ARCHITECTURAL REVIEW COMMITTEE MEMORANDUM

SUBJECT: FUZION FIVE RESTAURANT, REQUESTING A LAND USE PERMIT AND A WAIVER FOR AN EXPANDED PARKLET LOCATED AT 285 SOUTH PALM CANYON DRIVE, ZONE CBD, (CASE 21-094 LUP). (AP)

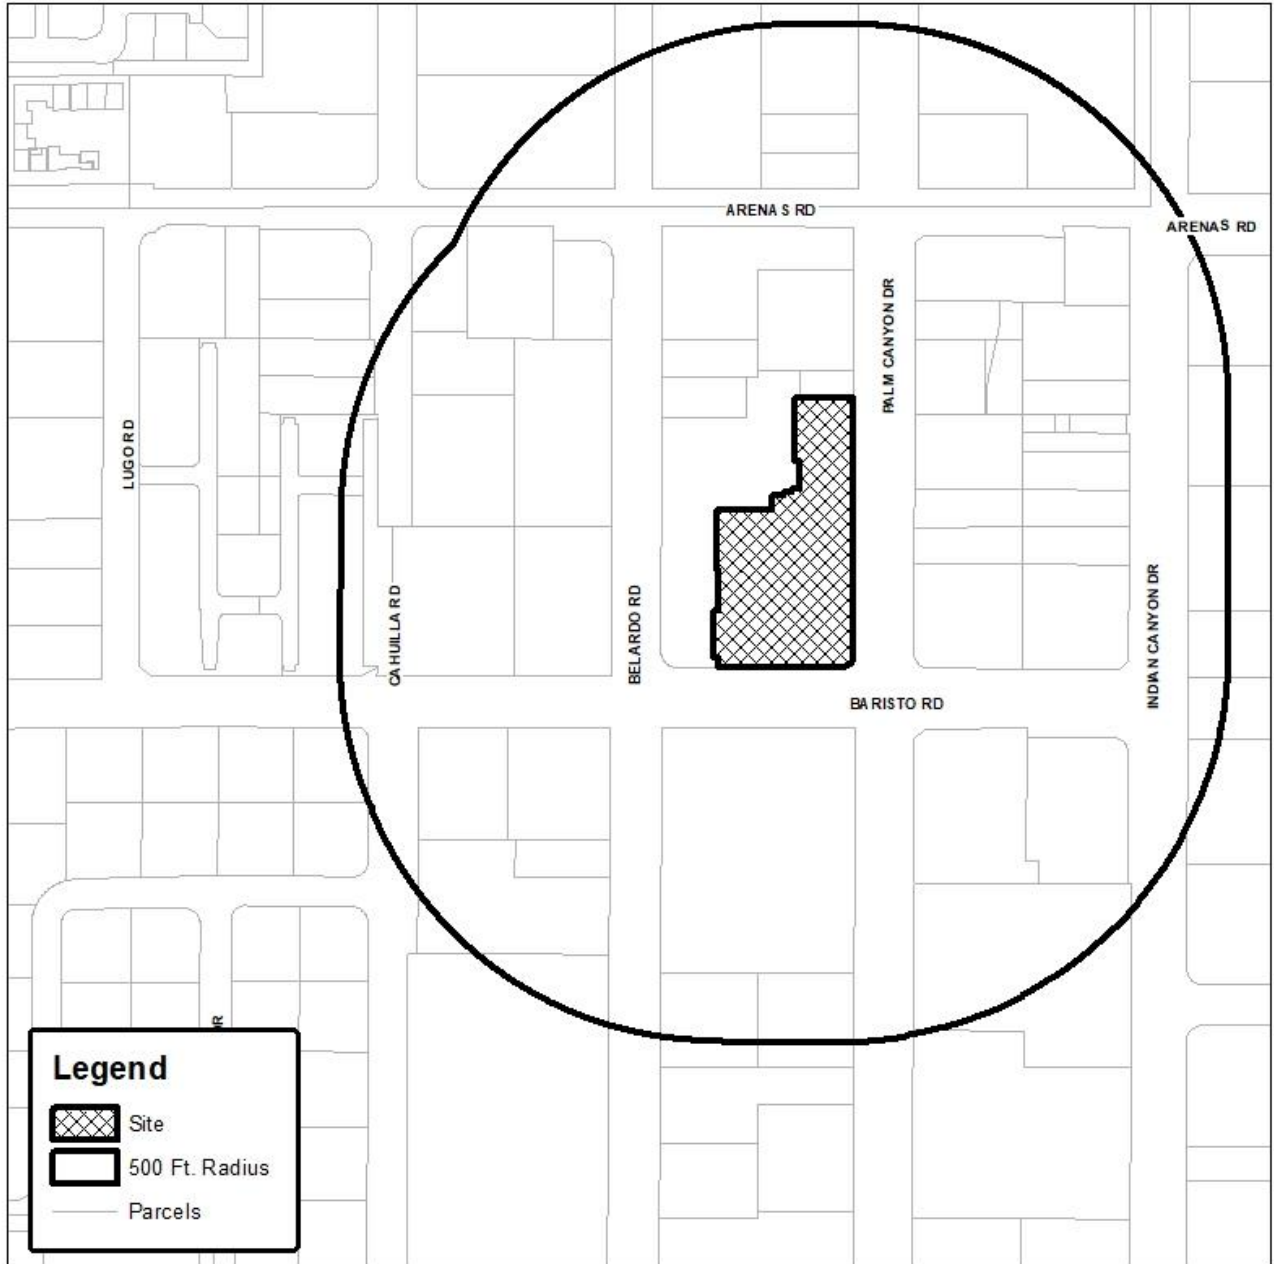
The proposed parklet will be an enhancement to the surrounding area. The parklet complies with the design standards set forth by the City Council and therefore, Staff recommends that the ARC approve, subject to the following conditions:

- Remove all Krails.
- Incorporate the ceramic potted plants within parklet.
- Remove the red wooden structure around existing parklet or cover the exterior side of the wooden structure so that it is solid and paint a desert neutral color.
